Docket Item # 11
BAR CASE # 2008-0218

BAR Meeting
December 3, 2008

ISSUE: Addition and Alterations
APPLICANT: Rust Orling Architecture
LOCATION: 617/619 South Lee Street
ZONE: RM/Residential

Figure 1: Site Plan and Addition Elevations

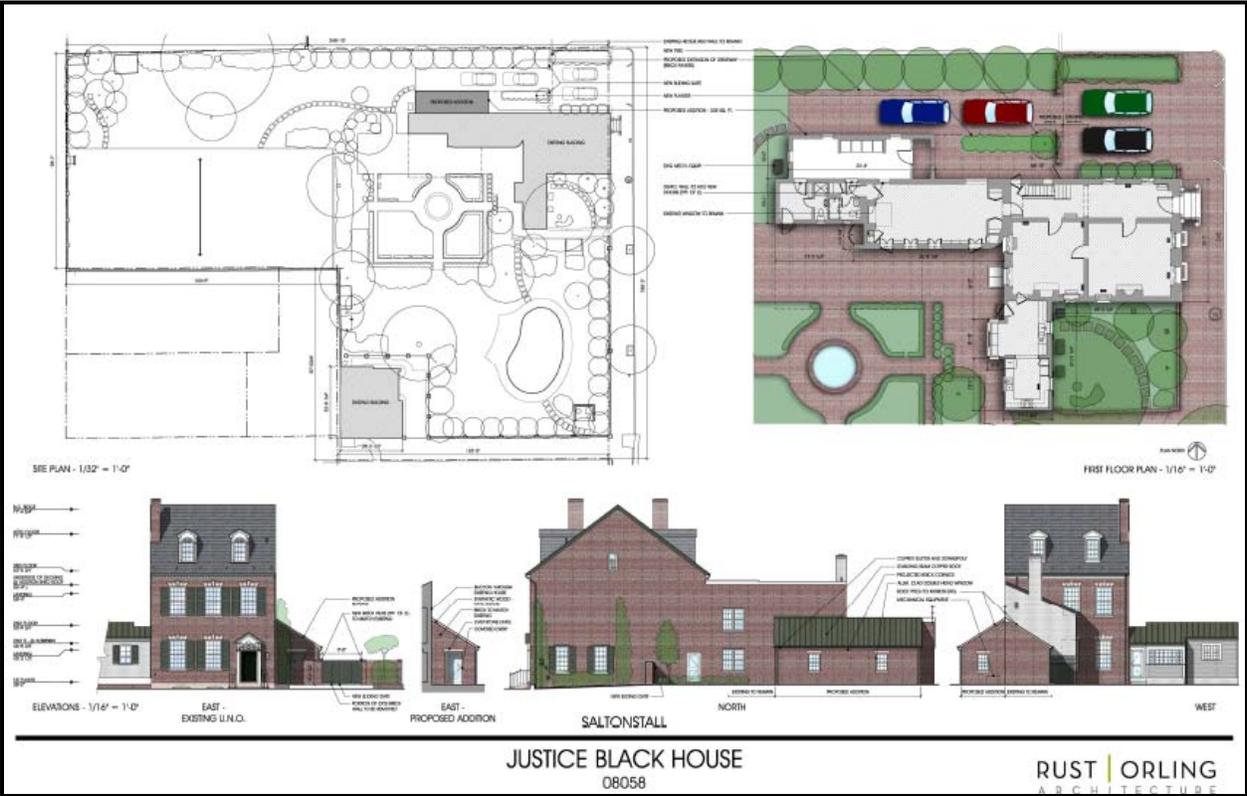
In the opinion of Staff, the proposed mudroom addition is appropriate and compatible with the late 18th century Federal style Justice Black house. The one story addition will be set back 66'

from the front building line and will be minimally visible; only the top portion of the flounder addition will be visible from the public right-of-way. The design of the addition is compatible in style, massing and fenestration to the historic house and conforms to the *Design Guidelines* for residential additions. In keeping with the recommendations contained in the *Guidelines*, the addition was designed as a background building "...which allow historic structures to maintain the primary visual importance." While the addition introduces a new mass into the side yard, it retains the integrity of the historic portion of the house because of its significant setback from the front property line and its limited visibility. Staff also does not object to the proposed use of the clad windows and door, or the use of synthetic wood rakeboard, because of the significant setback of the addition and because it will help distinguish the new addition from the historic house.

While Staff believes that the proposed 9' wood gate meets the recommendations contained in the *Design Guidelines* for Fences, Garden Walls & Gates, VDHR has requested detailed design drawings of the proposed gate. The applicant should also submit detailed gate plans for Staff review.

1. That the applicant provide detailed design plans for the proposed access gate to the both the Virginia Department of Historic Resources and BAR Staff for review and approval.
